RE: Review type: FAA Form 7460-1
Aeronautical Study #: 89-AEA-0451-OE
Nearest Airport: Keller Bros. &
Millard

re: Study 89-AEA-0452-OE
Raystay Company LPTV Application in
Lancaster, Pennsylvania

ELECTROMAGNETIC COMPATIBILITY REQUEST

re: Study 89-AEA-0451-OE
Raystay Company LPTV Application in
Lebanon, Pennsylvania

Figure 5
Horizontal Plot of
Relative Field from B16UA Ant
Oriented at N-286-E

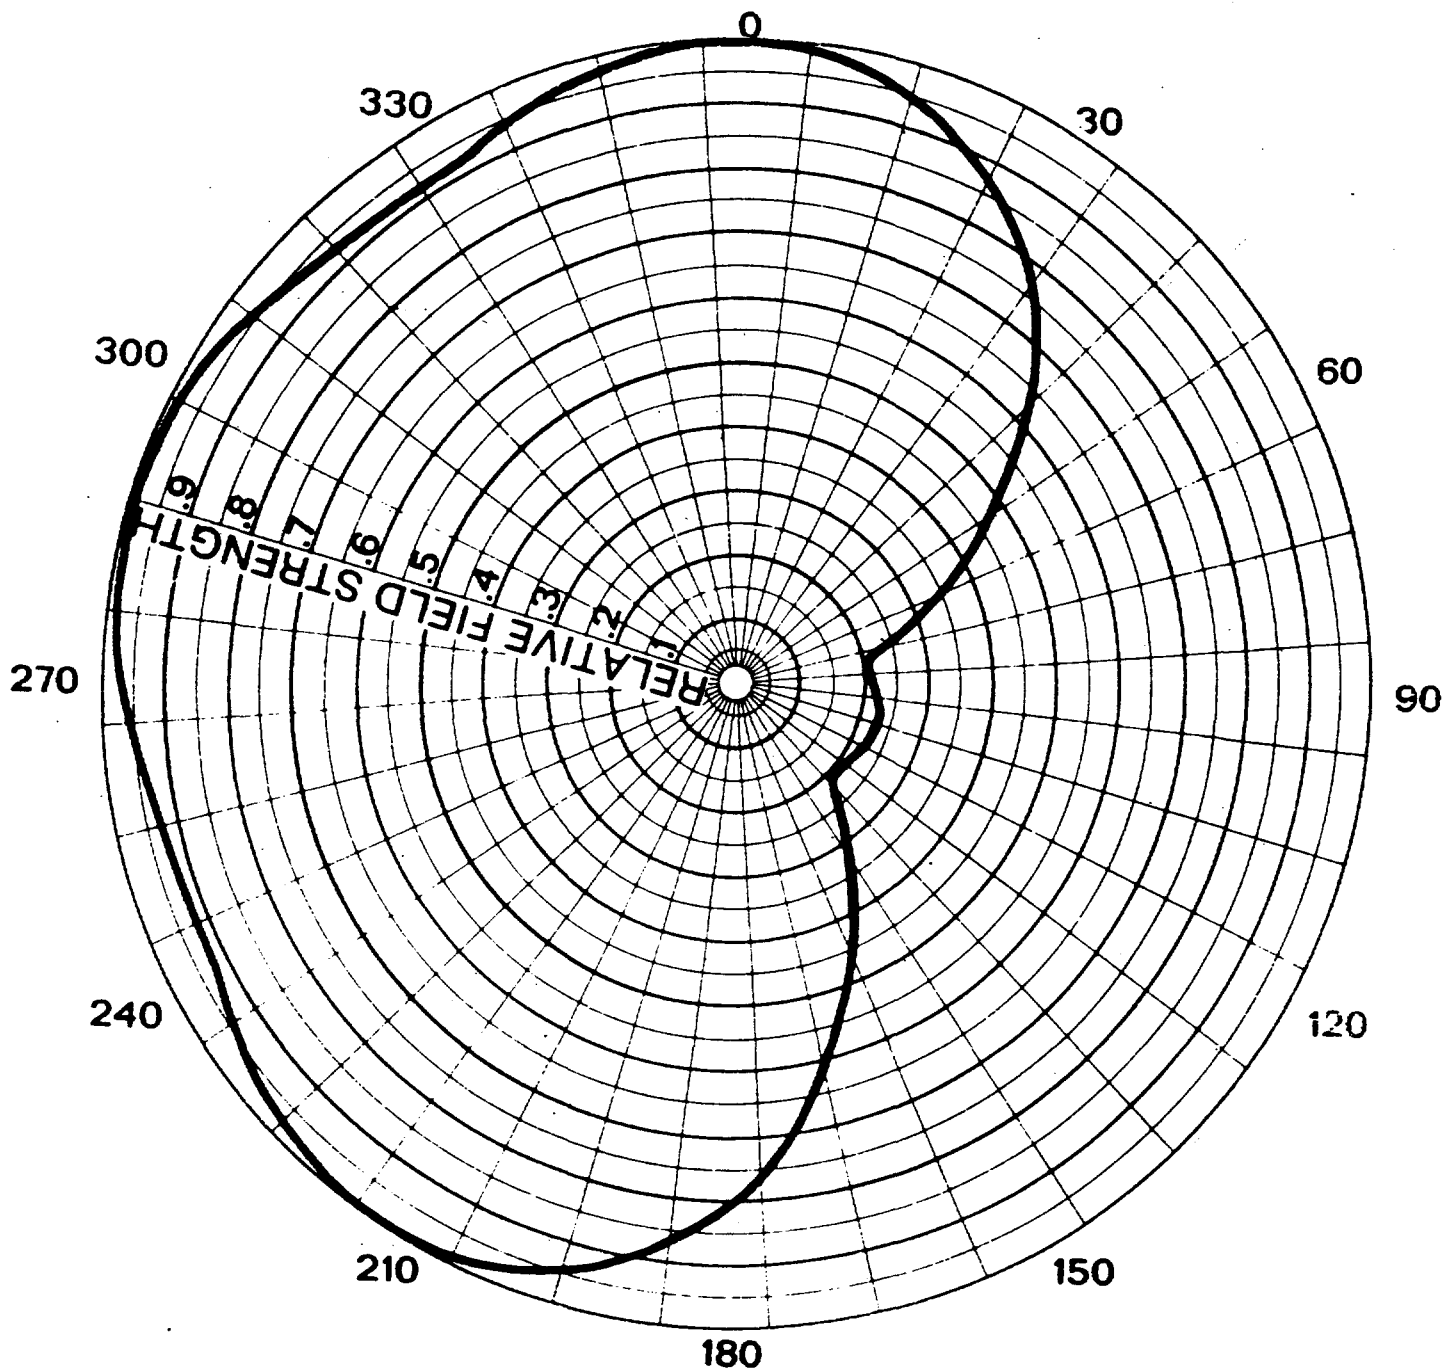
The applicant's proposed operation specifies approximately 21.6 dB of suppression by: 1) L_p , polarization loss of 16 dB because the applicant proposes horizontal (only) polarization from its antenna; 2) L_d , Antenna vertical directivity of approximately 5.2 dB (a -2 degree beam tilt is proposed), where the vertical radiation characteristic or vertical shape factor of the proposed antenna is herewith provided in the attached Figure 6 of the Application before the FCC; and EIRP, Effective Radiation would be reduced at the azimuthal angle subtended from the proposed LPTV station and the FAA site by approximately 0.42 dB. Our calculation shows this azimuthal angle to be approximately 14.9 degrees true, where the proposed LPTV directional antenna would be pointed at 286 degrees true, as shown in the attached Figures 4 and 5 of the Application.

Based on an agreement between the FAA and FCC in 1981, your transmitter must not exceed -4 dBm fundamental, and -104 dBm spurious signal level at our site.

The sum of these items results in approximately 21.6 dB spurious signal attenuation. Per the attached letter from the transmitter vendor, an additional 18 dB (a total of 78 dB) is provided below the video carrier frequency in the 225 to 400 MHz band and an additional 27 dB (a total of 87 dB) is provided in the 108 to 137 MHz band. Adding 21.6 dB from the proposed antenna parameters and an additional 18 dB from the transmitter specification results in 39.6 dB, which is in excess of the guideline indicated, 26 dB additional spurious radiation attenuation.

Figure 5
Horizontal Plot of
Relative Field from B16UA Ant
Oriented at N-205.3-E
Channel 38
Raystay Company
Lebanon, Pennsylvania

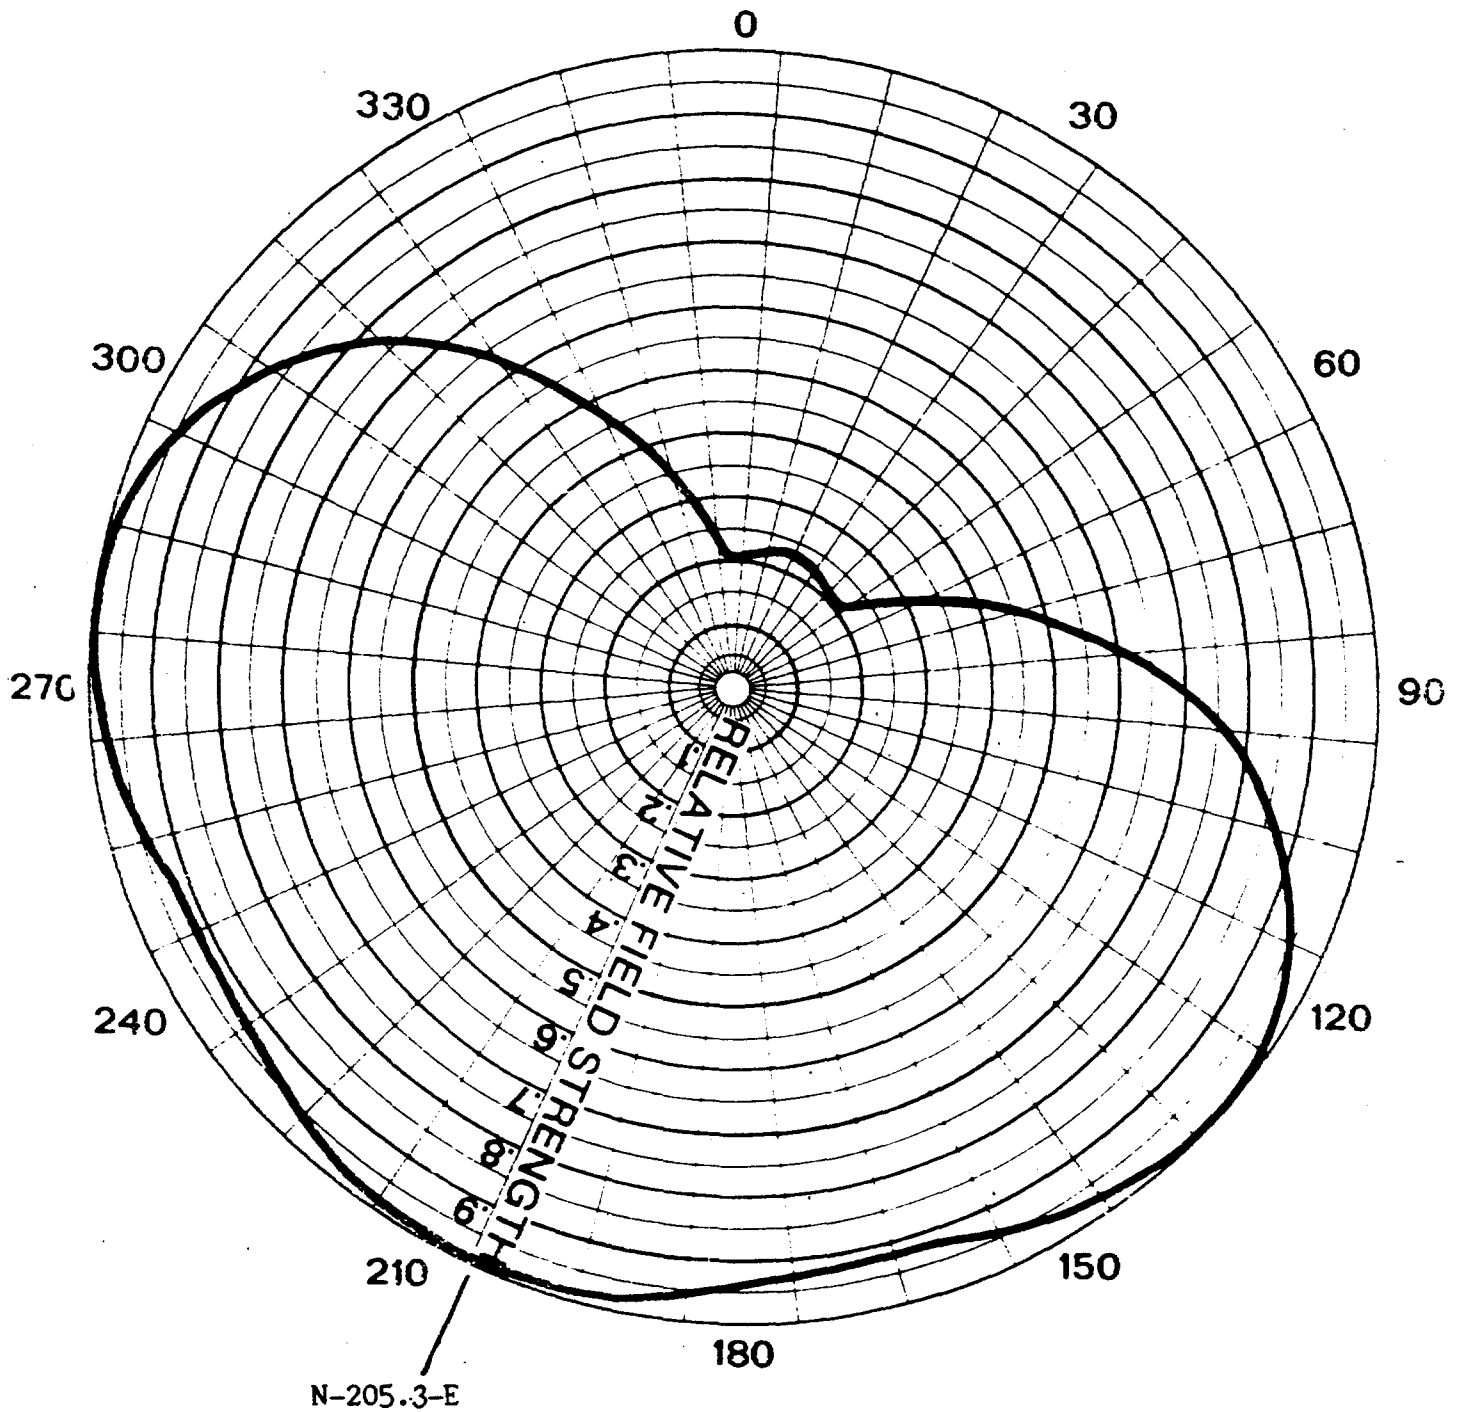
The applicant's proposed operation specifies approximately 23.6 dB of suppression by: 1) Lp, polarization loss of 16 dB because the applicant proposes horizontal (only) polarization from its antenna; 2) Ld, Antenna vertical directivity of approximately 5.6 dB (a -2 degree beam tilt is proposed), where the vertical radiation characteristic or vertical shape factor of the proposed antenna is herewith provided in the attached Figure 6 of the Application before the FCC; and 3) EIRP, Effective Radiation would be reduced by a directional antenna at the azimuthal angle subtended from the proposed LPTV station and the FAA site by approximately 2 dB. Our calculation shows this azimuthal angle to be approximately 313 degrees true, where the proposed LPTV directional antenna would be pointed at 205.3 degrees true, as shown in the attached Figures 4 and 5 of the Application.

Based on an agreement between the FAA and FCC in 1981, your transmitter must not exceed -4 dBm fundamental, and -104 dBm spurious signal level at our site.

The sum of these items results in approximately 23.6 dB spurious signal attenuation, which is in excess of the guideline indicated, 18 dB additional spurious radiation attenuation.

Per the attached letter from the transmitter vendor, an additional 18 dB (a total of 78 dB) is also provided below the video carrier frequency in the 225 to 400 MHz band and an additional 27 dB (a total of 87 dB) is provided in the 108 to 137 MHz band.
